RE: SUB 2002-19 -- Final Plat of Angel's Landing Addition

At the regular meeting of the Subdivision Committee of the Metropolitan Area Planning Commission on Thursday, April 11, 2002, the above captioned plat was considered. The action of the Committee was to approve the one-step final plat, subject to the following:

CASE NUMBER: SUB 2002-19 -- ANGEL'S LANDING ADDITION

An Addition to Sedgwick County, Kansas

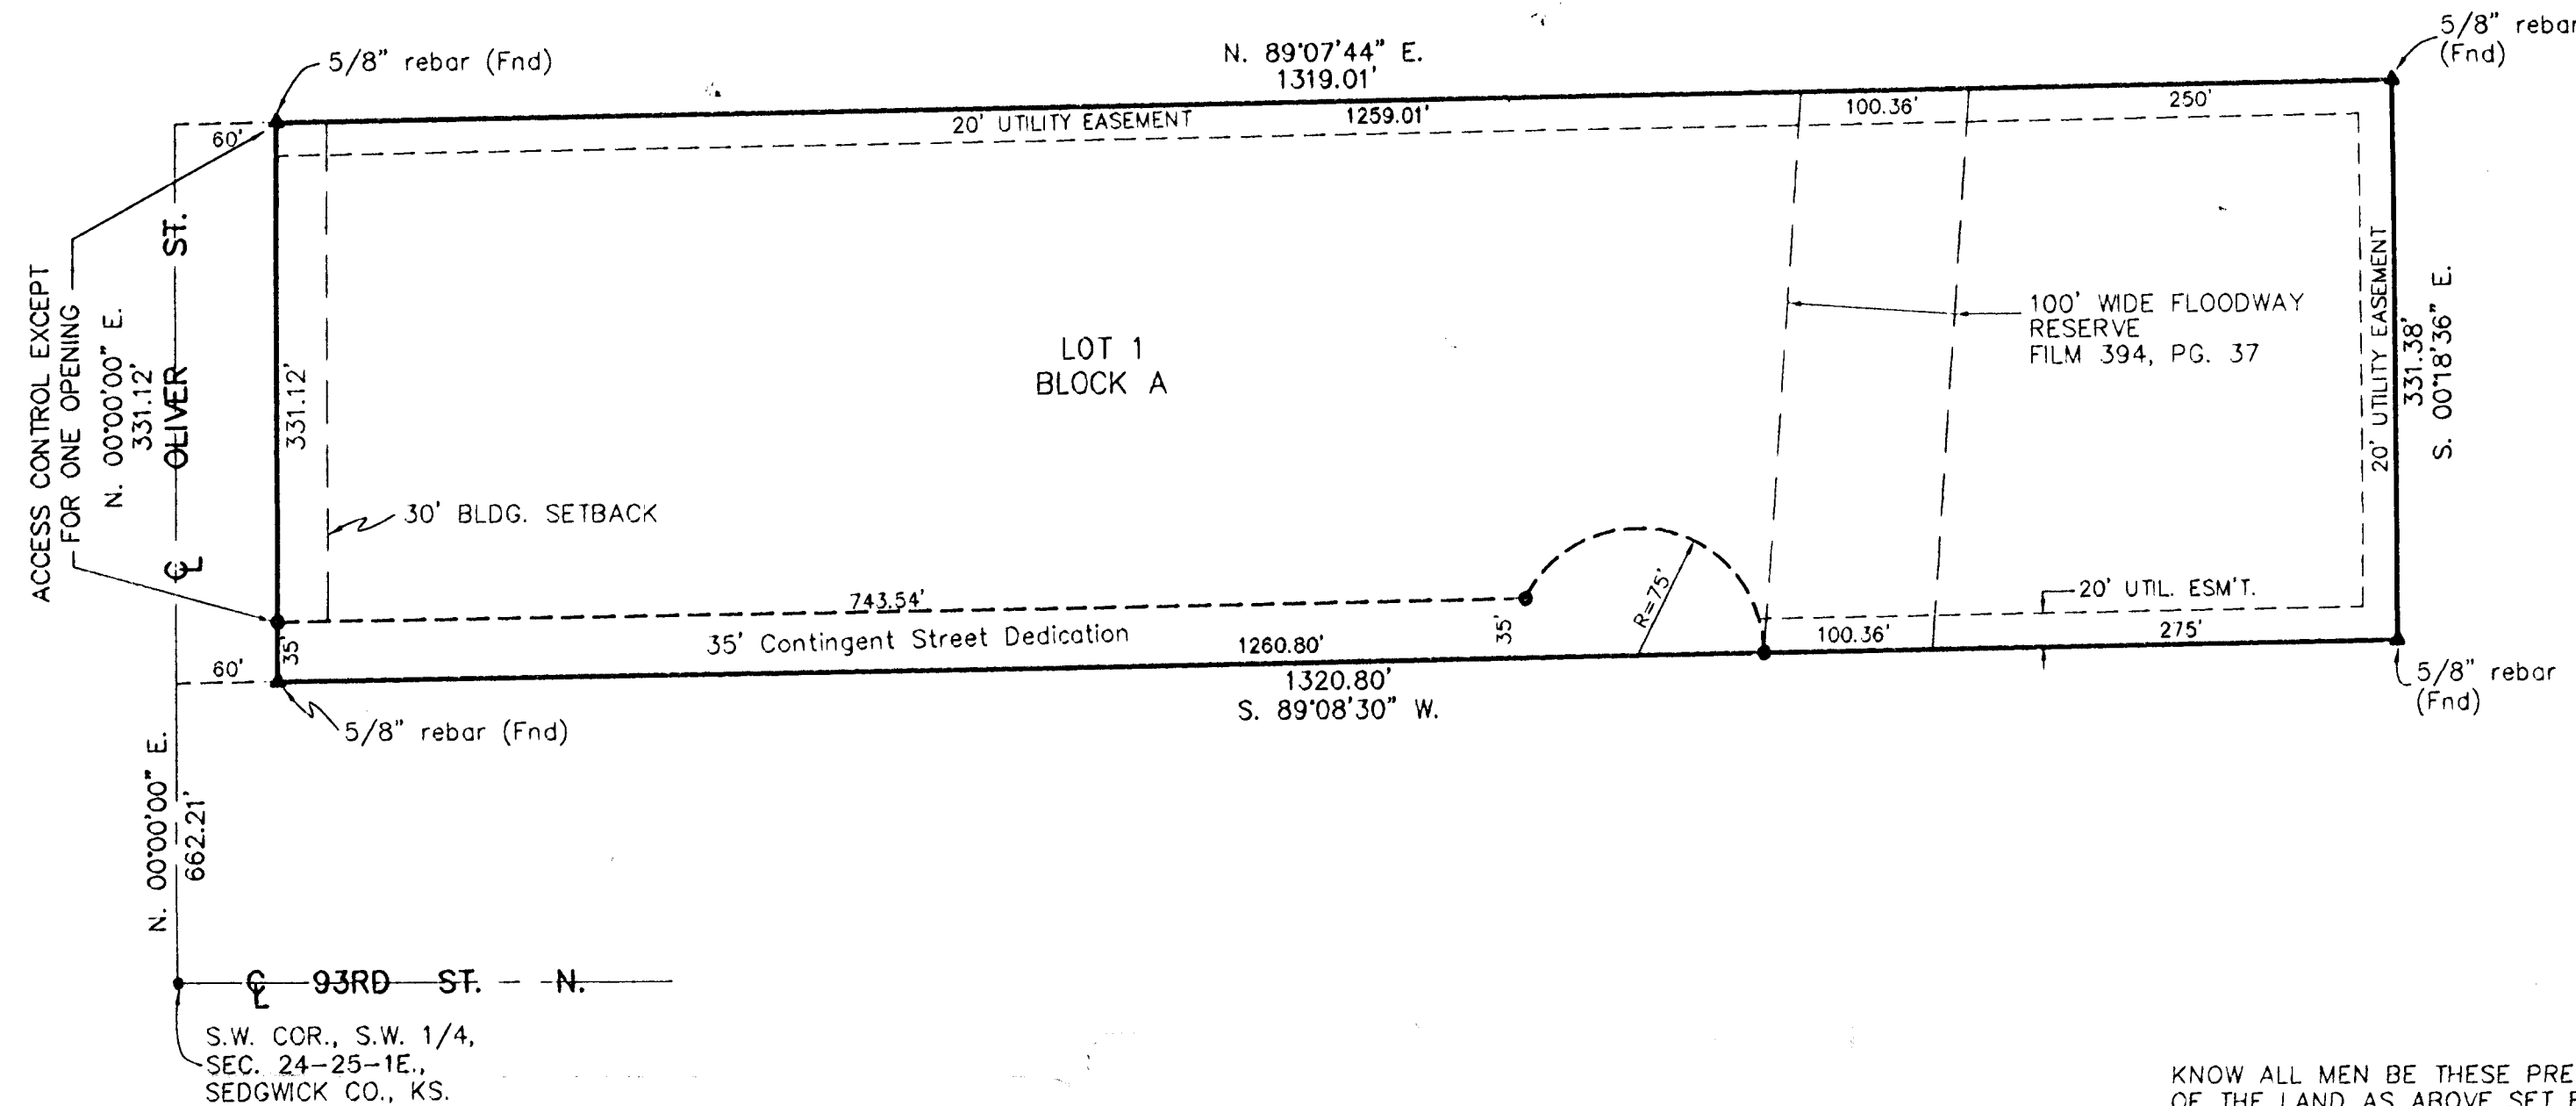
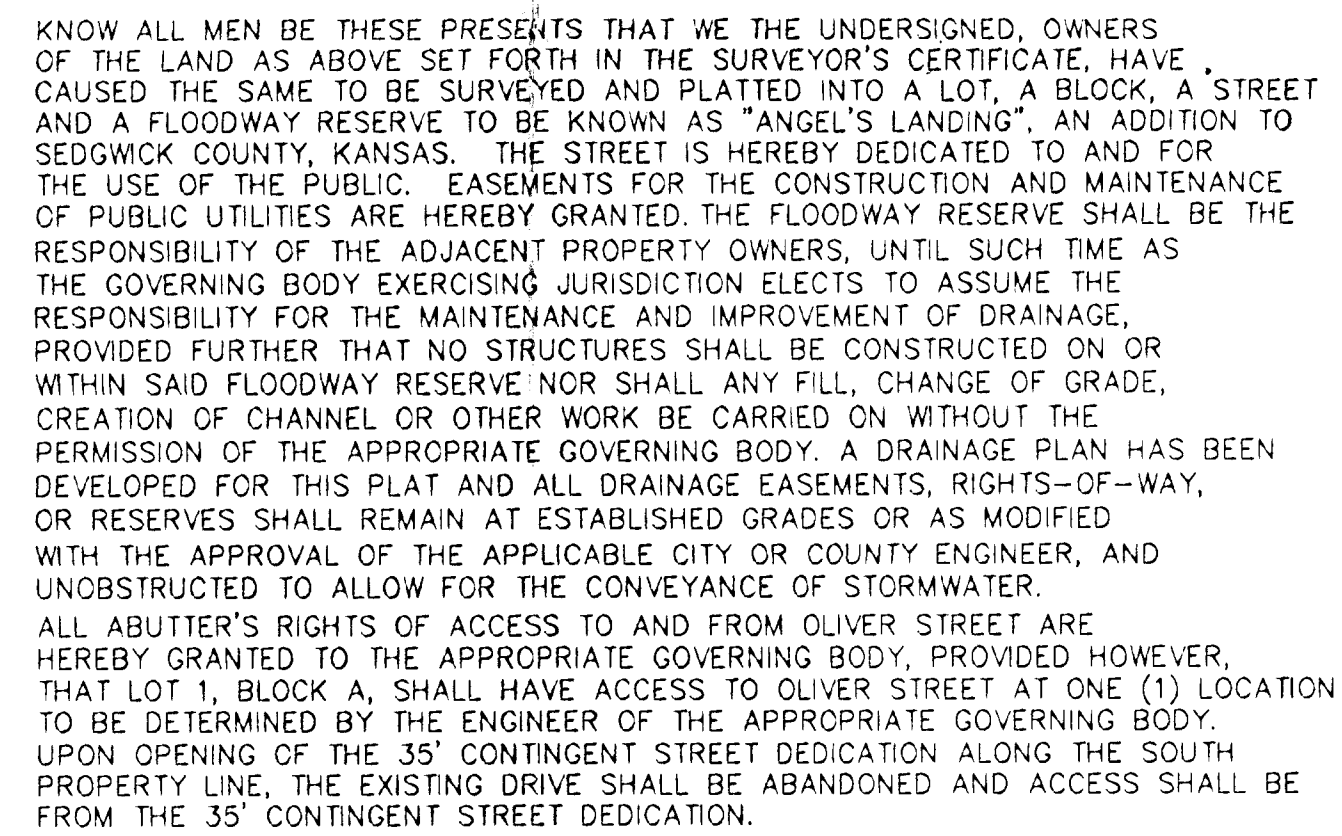
- E. The Applicant should provide a 35-ft contingent dedication of street right-of-way along the south property line, extending to the floodway reserve in order to provide potential street connection to adjoining properties. On the final plat, the contingent dedication of right-of-way needs to be referenced in the plat's text.

The contingent street dedication has been provided as requested.
- F. **County Engineering** has required complete access control except for the south 35 feet.

- G. The plat's text shall state that the access opening along Oliver would be required to be closed when the new street is constructed.
- H. The signature line for the County Commissioners Chairman needs to reference "Ben Sciortino".

- K. The plat's text shall include language that a drainage plan has been developed for the plat and that all drainage easements, rights-of-way, or reserves shall remain at established grades or as modified with the approval of the applicable City or County Engineer, and unobstructed to allow for the conveyance of stormwater.

- M. The applicant's engineer is advised that the Register of Deeds is requiring the name(s) of the notary public, who acknowledges the signatures on this plat, to be printed beneath the notary's signature.
